LONGWALLS 4 & 5 AND MAINGATES 6, 7 & 8

ADDENDUM TO RESPONSE TO SUBMISSIONS

November 2012

Figure 7 - LW4 Centreline Strains Relative to Start and Finish Positions

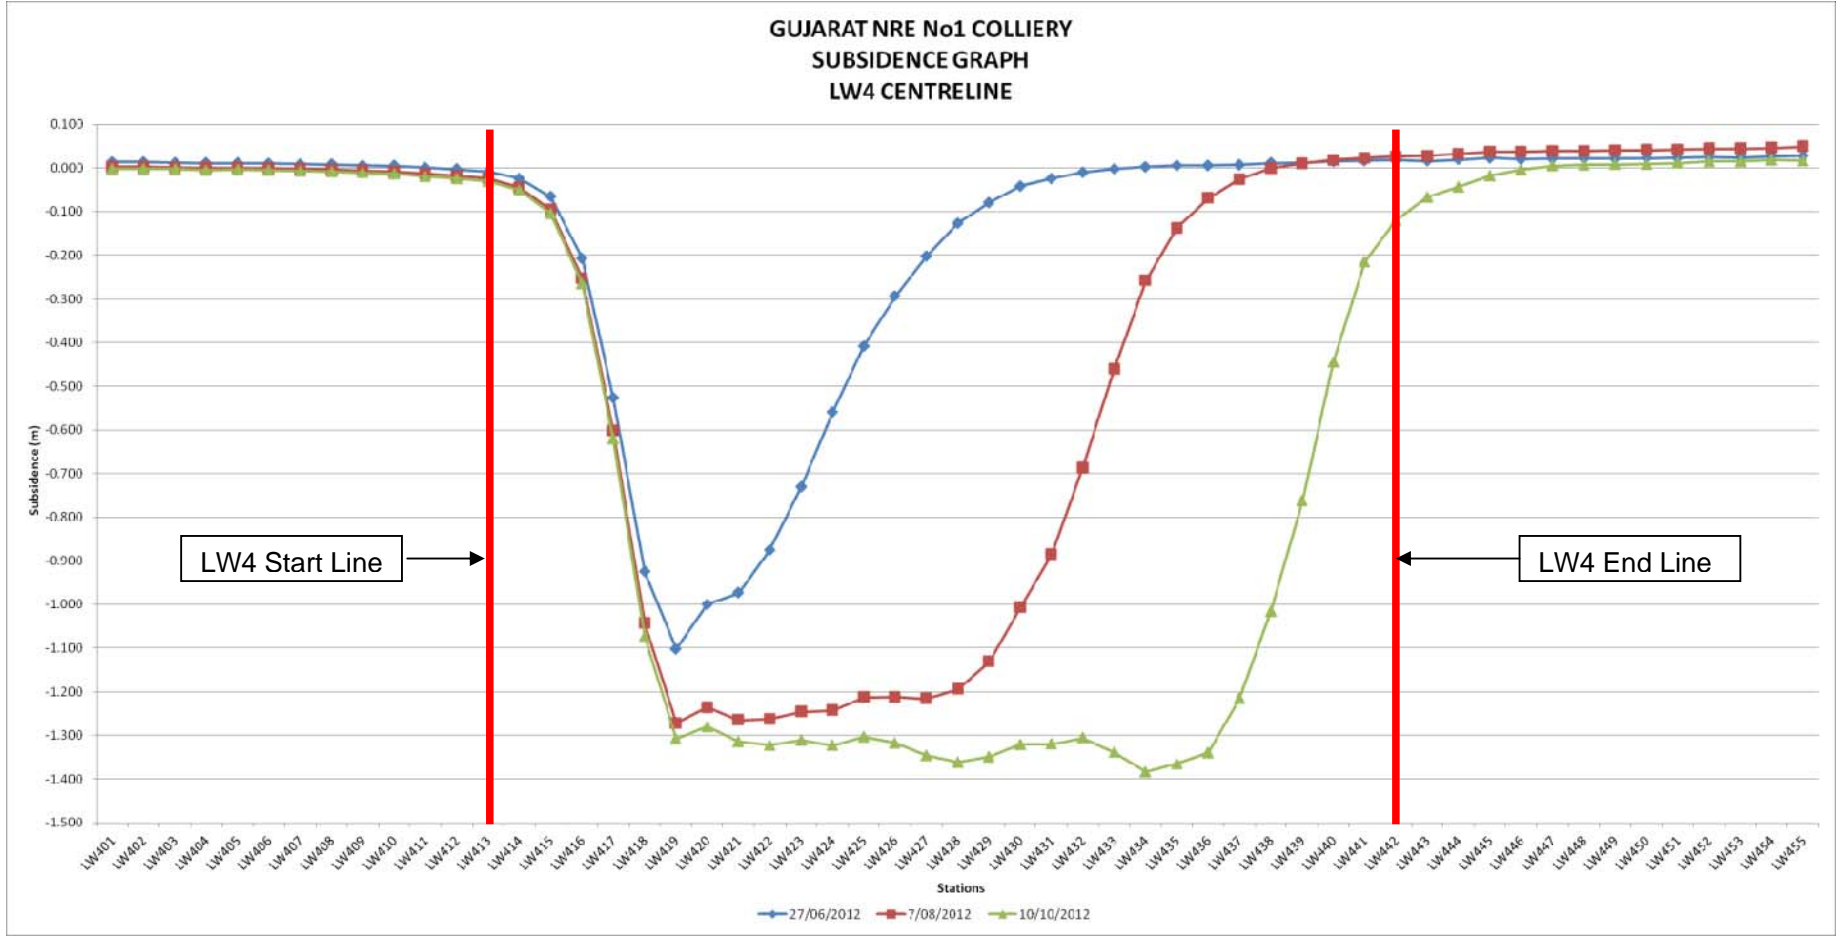
Lack of Updated Subsidence Predictions Based on LW4 Outcomes

NRE has been criticised for not updating subsidence predictions based on the outcomes of the LW4 subsidence monitoring.

The most recent data indicates that the maximum subsidence experienced over LW 4 was 1384mm (138.4cm or 1.384m). Predictions of subsidence for LW5 contained in Table 7.1 of the Longwalls 4 and 5; Maingates 6, 7 & 8 EA indicate a predicted maximum subsidence of 1.145m. This is a difference of 234mm (23cm or 0.23m).

Given that the geological conditions for LW5 are very similar to LW4 then the difference between the observed subsidence of LW4 and the predictions of LW5 are only in the order of 16% based on the **original subsidence predictions**. These original subsidence predictions for LW5 will be modified if necessary when final analysis of the subsidence monitoring data is completed by geotechnical experts.

The most important aspect that has been shown by the preliminary subsidence data is that the subsidence profile of LW4 is predominantly constrained to within the limits of the longwall panel mined in the Wongawilli Seam. The effect of the overlying Bulli Seam goaf is evident in the difference in behaviour between the north subsidence line (NX shown in **Figure 2**) where the Bulli Seam goaf extends either side of LW4 and the south subsidence line (SX shown in **Figure 3**) where the Bulli Seam goaf coincidentally extends only as far as the edges of the Longwall 4 goaf. The Balgownie Seam goaf is not evident in the subsidence profiles. Preliminary indications are that strains are confined to the inside edge of the chain pillars and the centre of the longwall as shown in **Figure 4** and **Figure 5**. The maximum observed horizontal tensile strain over the chain pillars was 4.68mm/m of tensile or expansive strain on the SX subsidence survey line. The maximum observed horizontal compressive strain was 5.03mm/m of compressive strain on the NX subsidence survey line. This compares favourably to the currently predicted 10-12mm/m maximum strain for LW5. **Figure 6** and **Figure 7** show that the vertical subsidence and strain are also constrained primarily to the LW panel with little extension beyond start and finish lines.

Figure 8 - Swamps with New LW5 Layout

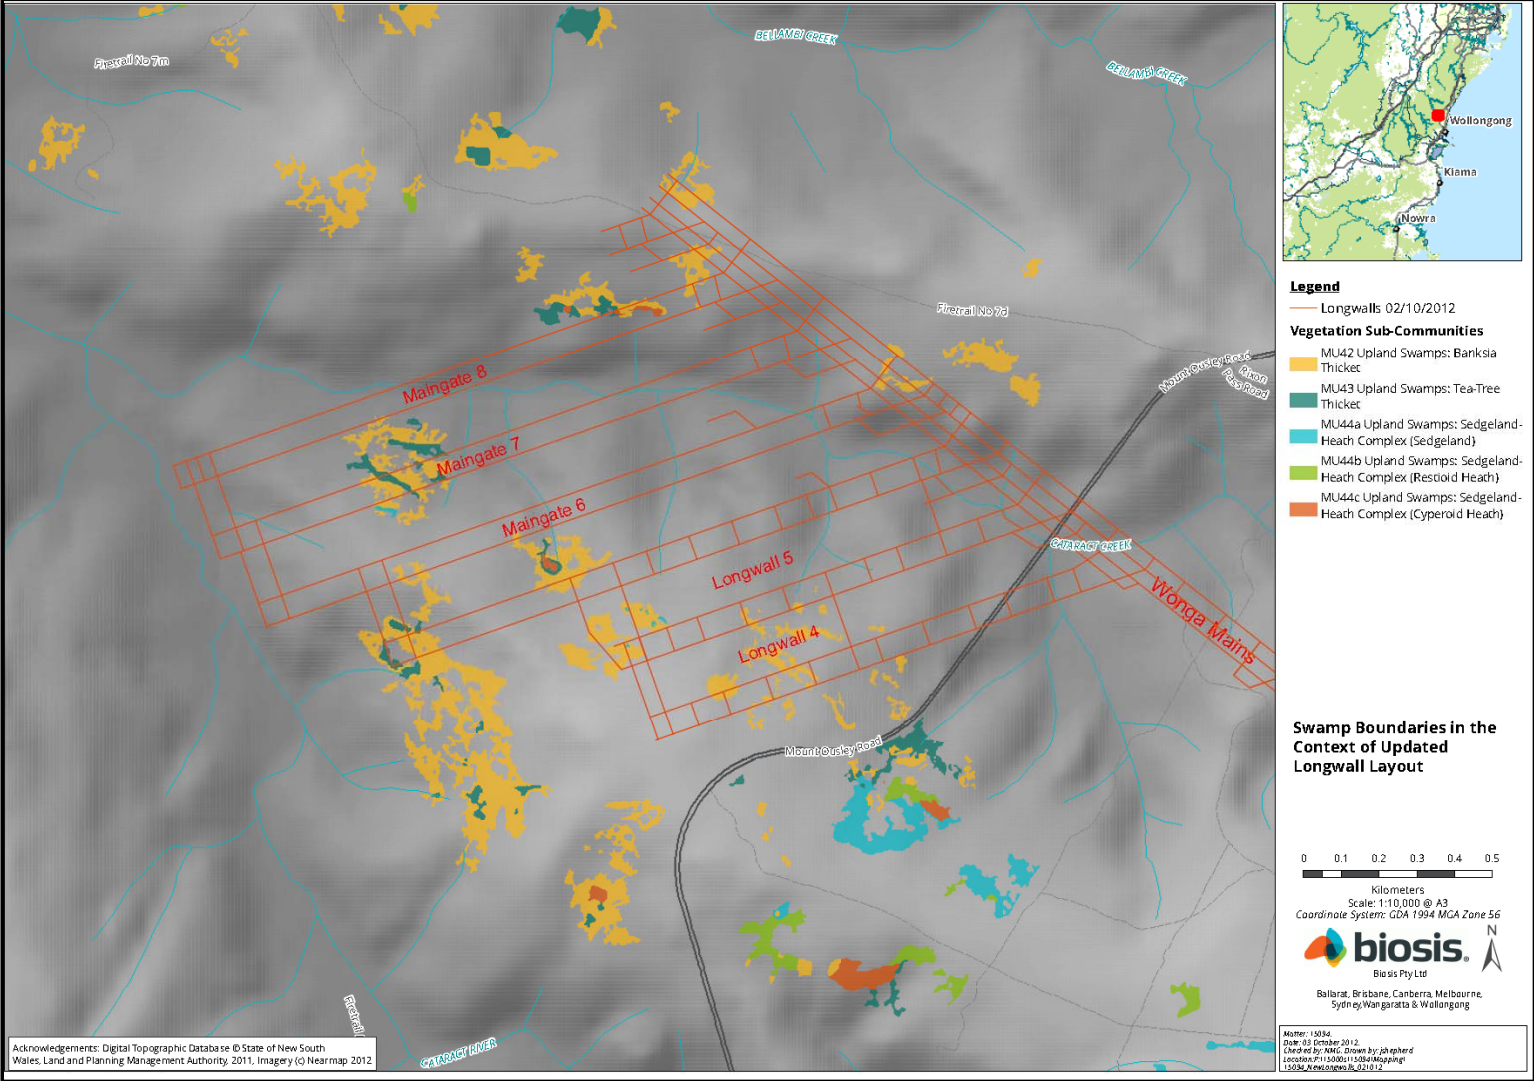
OEH have stated that concerns remain regarding impacts on upland swamps from the extraction of LW5 including:

- the Biosis Upland Swamp Assessment report submitted with the original NRE Response to Submissions report states low, not negligible, impact will eventuate from LW5 extraction;
- inadequate subsidence modelling as NRE has not taken into account additional subsidence data from LW4 and updated its subsidence impact assessment on swamps;
- inadequate baseline monitoring;
- inadequate consideration of longwall layout to reduce impact on swamps; and
- inadequate management planning

The statement in particular that swamp CCUS4, which is located over proposed LW6 in the Wonga East area, would receive low levels of impact was relates to its undermining by LW6, not LW5. Negligible impact is anticipated on CCUS4 from the extraction of LW 5 as preliminary indications from LW4 data are that the subsidence and strain are not anticipated to extend beyond the chain pillars of Maingate 5 to any significant extent as shown in Figure 1, Figure 2, Figure 3, Figure 4 and Figure 5 of this Addendum. If you apply the PAC (2010) subsidence criteria for LW5 only there is negligible risk of impact to this swamp.

As mentioned in the Flora and Fauna section in the original Response to Submissions, particularly pgs 37 – 39, NRE has relocated the start line of LW5 which has reduced the likelihood of impact to significant swamps to negligible levels as both strains and subsidence are likely to be significantly reduced as mentioned above. The new LW5 layout with swamp types overlain as shown in the original Response to Submissions report is reproduced in **Figure 8**. It can also be noted in that Figure that the remapped CCUS4 is behind the LW5 start line. Given the reasonable assumption that subsidence from LW5 will be relatively similar to the preliminary subsidence data from LW4, CCUS4 will undergo negligible impact as it is outside the chain pillars of LW5 and behind the longwall start line.

Figure 10 - Subsidence Observed on P Line Pegs on Mt Ousley Rd

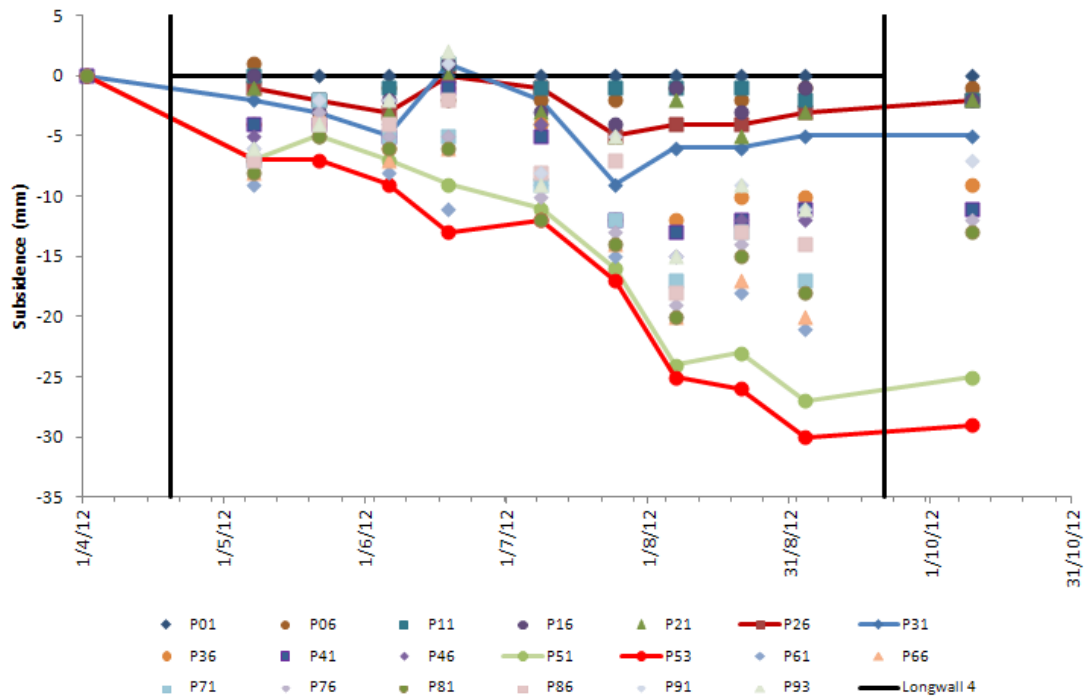
Very recent LW4 End of Panel visual surveys of Mt Ousley Rd have indicated the presence of four very minor cracks in the road pavement.

As shown in **Figure 10**, the subsidence has increased gradually and consistently as LW4 has been mined and looks to have stopped now that LW4 has finished. This movement is likely to recommence when LW5 is mined.

Figure 12 – Proposed Water Monitoring Locations along Cataract Creek and Amended CT1 Site (Previously CC6)

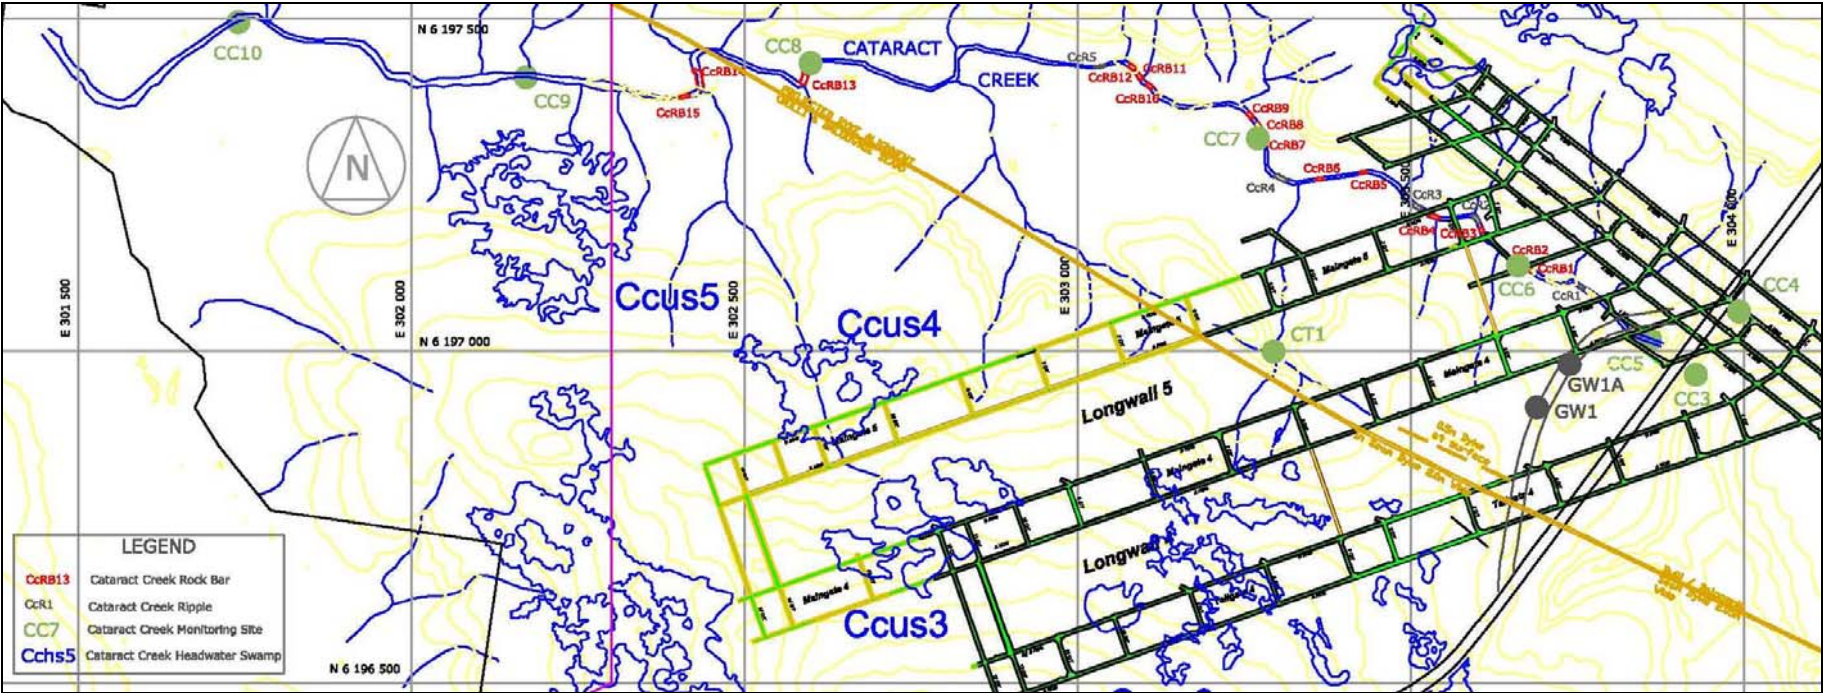
NRE has raised some issues that have come to light as part of the ongoing LW4 post extraction monitoring including cracking of the pavement on Mt Ousley Rd, the apparent drying out of a pool (CC6) being monitored in Cataract Creek and minor movement at the Picton Road bridge.

The inspection was conducted between sites on the eastern side of Mt Ousley Rd and the confluence of Tributary CT1 with Cataract Creek. Tributary CT1 was then followed to its headwaters. The inspection route can be seen on **Figure 12** and the outcomes of the inspection are outlined in **Table 2**.

As a result of the site inspection, the site shown as CC6 on the LW4 monitoring plan has now been renamed CT1 and a new installation location has been identified for CC6 within the stretch of Cataract Creek well upstream of where Tributary CT1 enters. Additional pool monitoring sites are also proposed and are shown as CC7 and CC8. The site shown as CC7 has been renamed CC9 to ensure downstream consistency in nomenclature. An application to the SCA is currently being developed to emplace the new pool depth loggers in this new location. The new pool depth logger locations are shown in **Figure 12** and an overview of renamed and new pool depth monitoring point areas are shown in **Table 3**.
